Proposed Ground Floor Plan - 1/50

Non-material amendments proposed in Red

Proposed First Floor Plan - 1/50

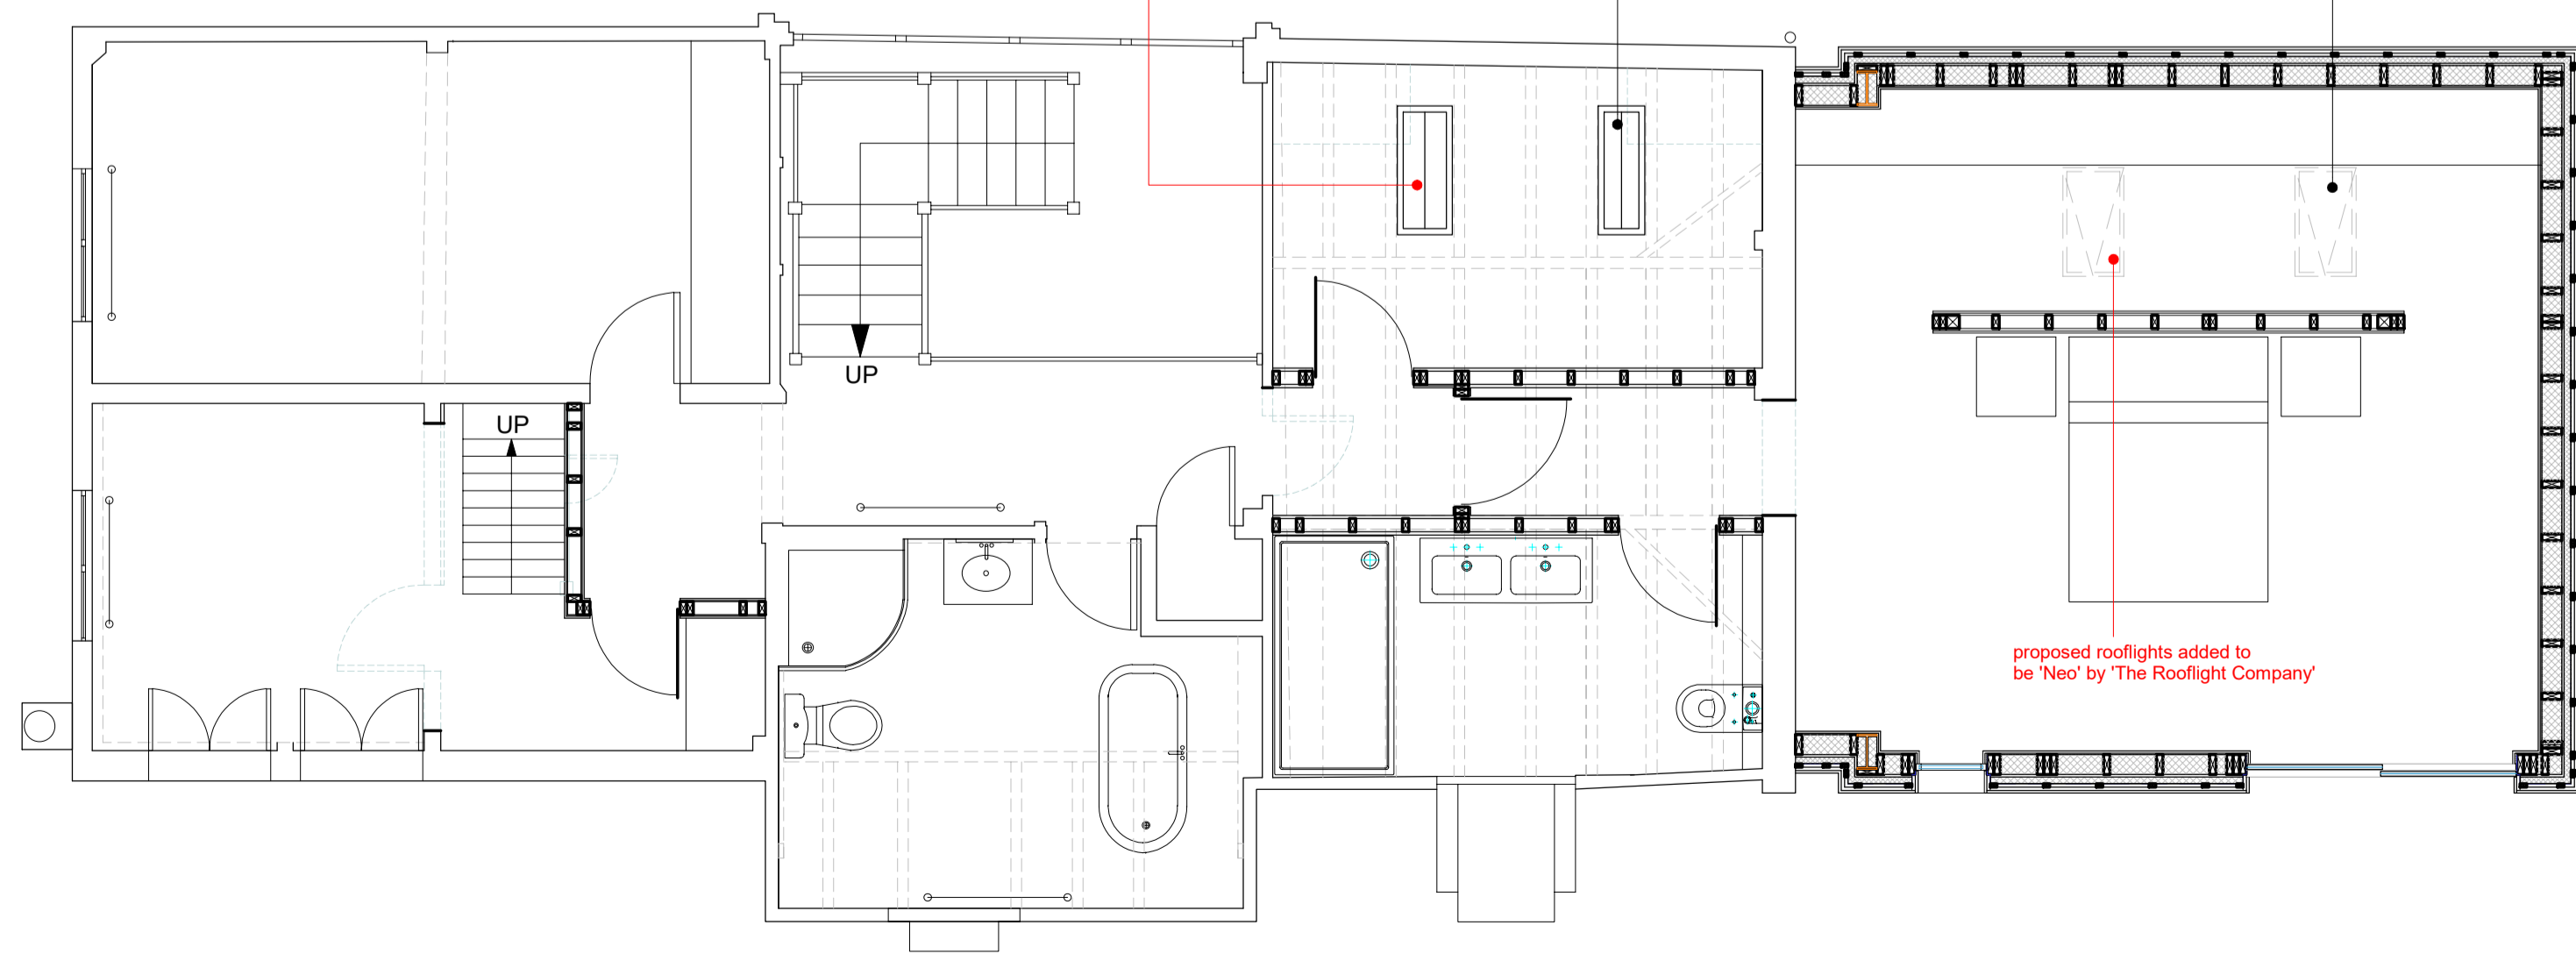
rooflight positions approved under ref 22/03533/HOUSE proposed to be adjusted to suit existing structure, thus mitigating cutting and trimming historic oak rafters.

proposed rooflights added to be 'Neo' by 'The Rooflight Company'

Proposed East Elevations - 1/100

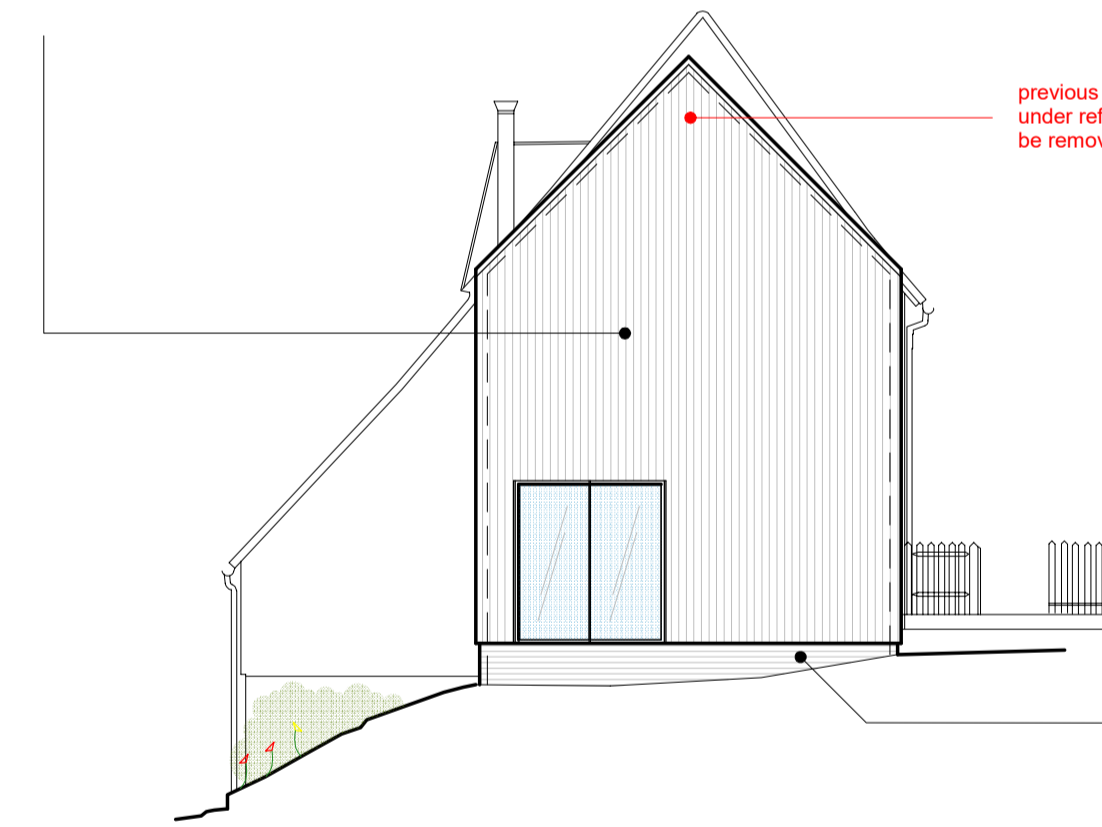
window positions approved under ref 22/03533/HOUSE proposed to be adjusted.

previous approved Zinc cladding under ref 22/03533/HOUSE proposed to be AtelierClad® Brushed-Grain Cladding in Charcoal (matte)

Proposed West Elevations - 1/100

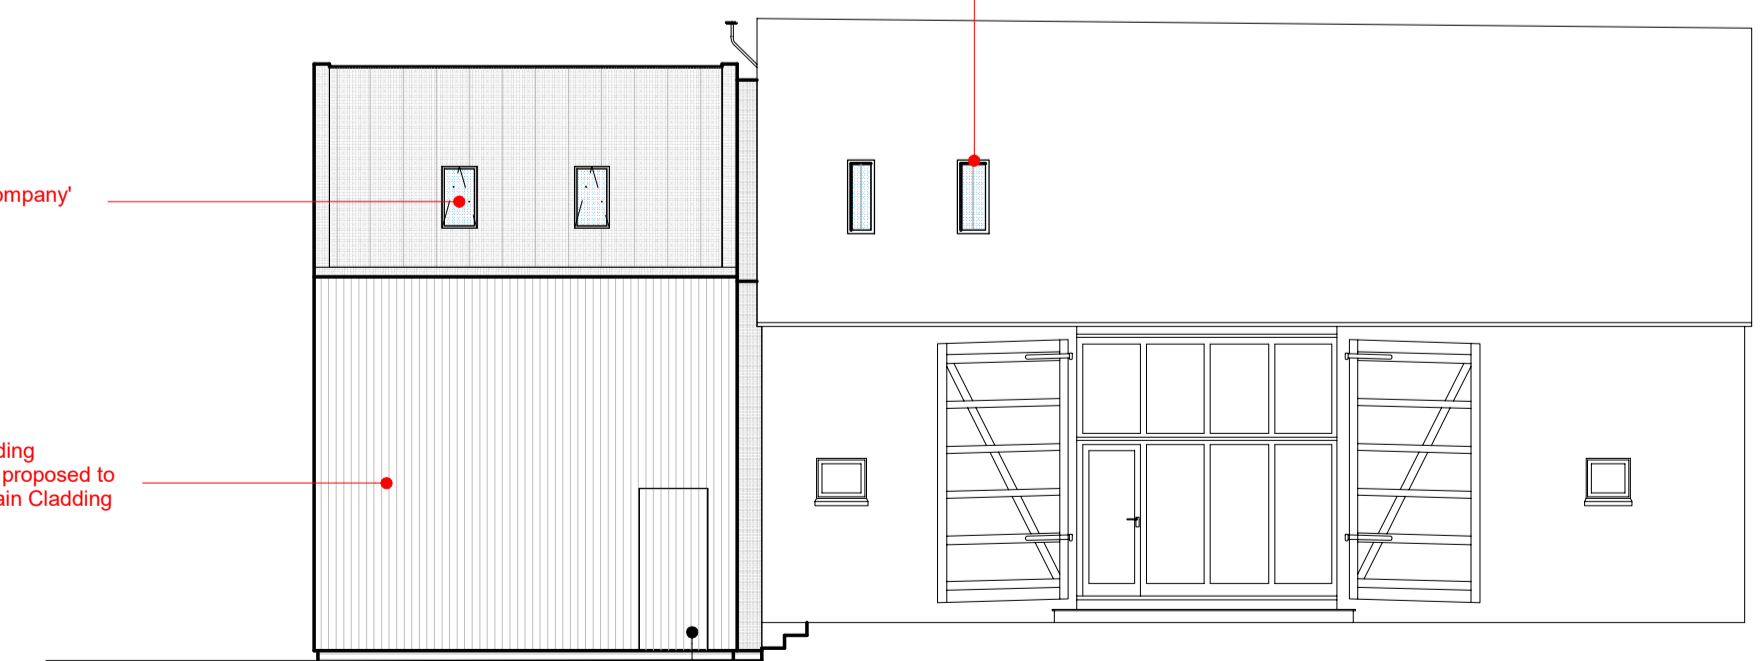
rooflight positions approved under ref 22/03533/HOUSE proposed to be adjusted to suit existing structure, thus mitigating cutting and trimming historic oak rafters.

proposed rooflights added to be 'Neo' by 'The Rooflight Company'

previous approved Zinc cladding under ref 22/03533/HOUSE proposed to be AtelierClad® Brushed-Grain Cladding in Charcoal (matte)
